BUILDING ASSESSMENT

NEWTON PUBLIC LIBRARY

May 2008

1.4.3

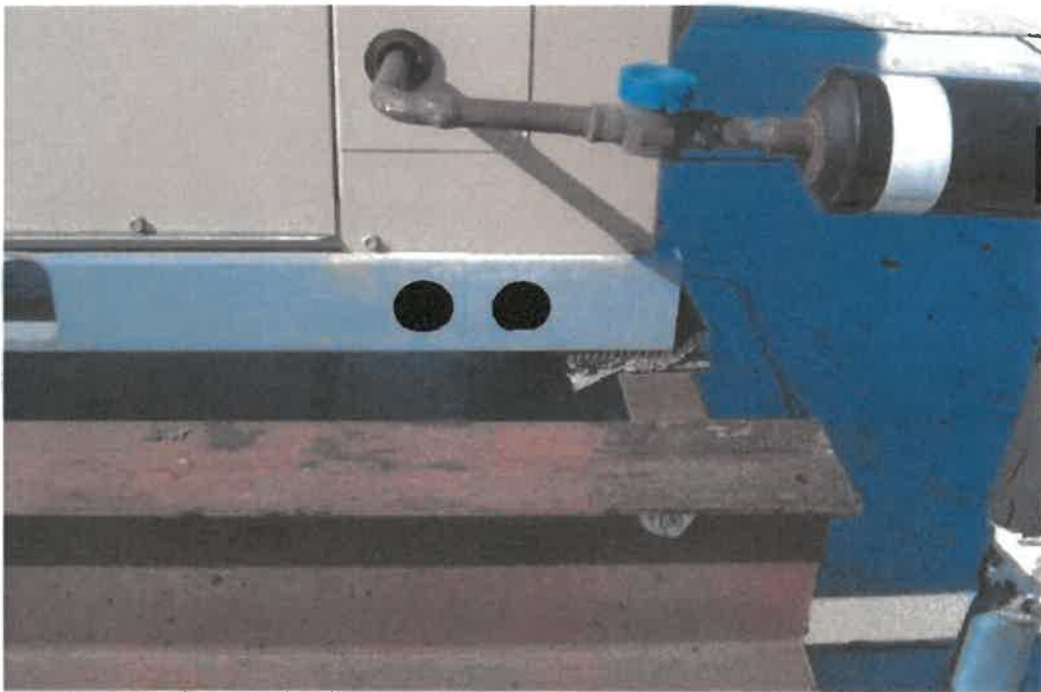
- 1.4.3 The wall between the lower floor south mechanical room and the adjacent work room should be extended to the underside of the floor above as a sound and smoke barrier.

4.1.1.5.1.2. – Replace Isolation Pads - Unit#1 – View #1879

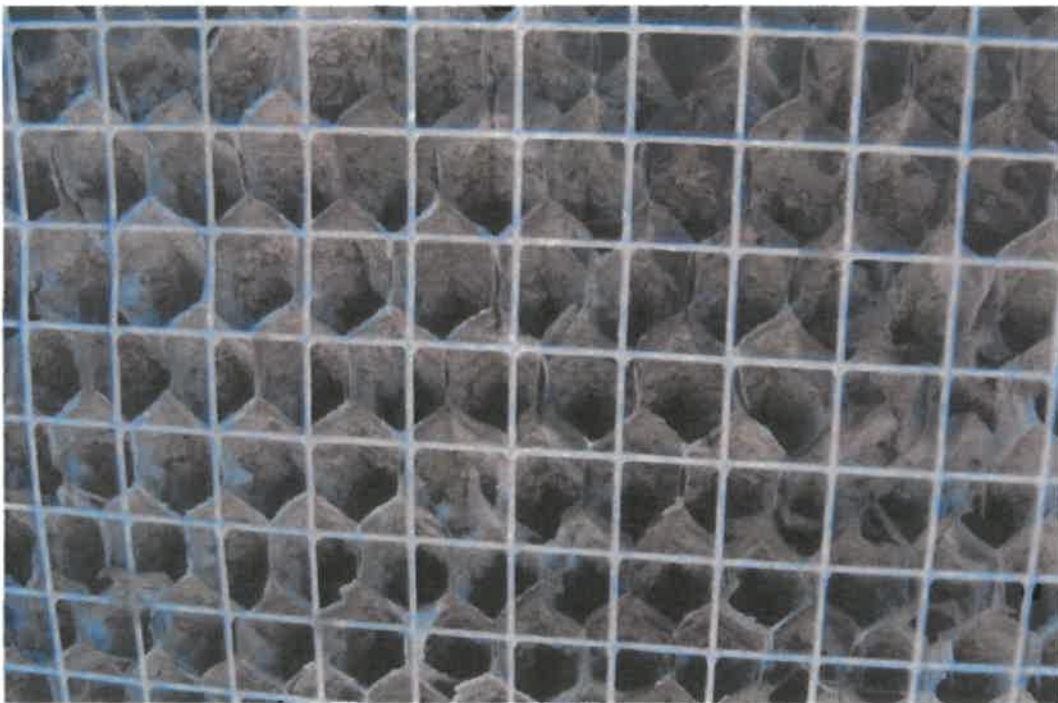
4.1.1.5.1.2. The vibration isolation pads are in a much deteriorated condition and should be replaced.

4.1.1.6.1.2. Deteriorated Pipe Insulation – Unit #2 – View 1909

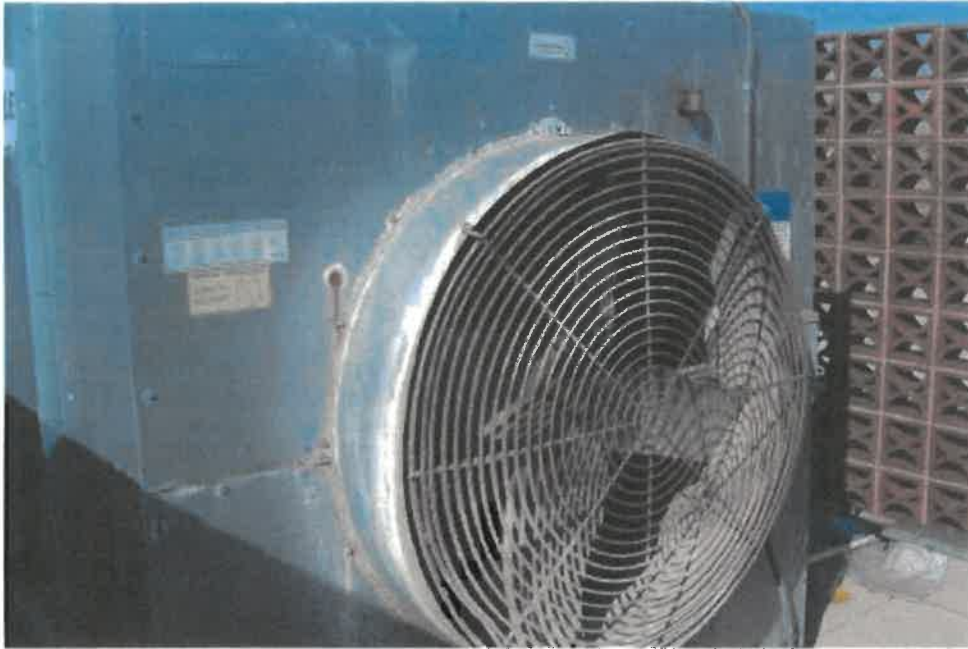
- 4.1.1.6.1.2. The refrigerant piping insulation is deteriorated and should be replaced. Replacement insulation should be coated with an ultra-violet resistant coating.

5.1.2. – Heat Trace Extension Cord – View 1864

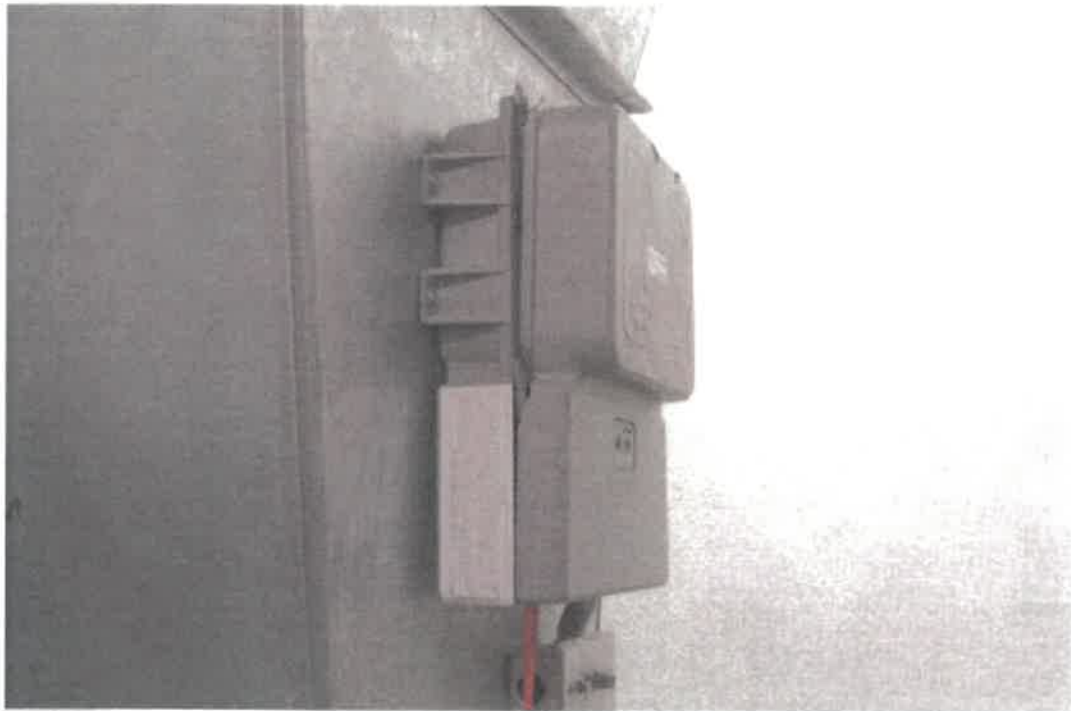
- 5.1.1. The cooling tower disconnect switch appears to have a damaged wire on Phase B [Blue Wire]. This should be repaired.
- 5.1.2. Add a convenience outlet at the cooling tower to allow removal of the semi-permanent extension cord used for the heat trace on the tower water piping.
- 5.1.3. A service drop for the locomotive cover building and area yard light goes over the SE Corner of the library roof about 2' above the roof. This is contrary to the National Electrical Code (NEC). This is something to be aware of and be cautious about when working on the roof. It is not an item that can be easily changed at this point unless a pole is added in the yard.
- 5.1.4. A lightning protection system is recommended according to the National Fire Protection Association [Standard #NFPA-780] for the library building.
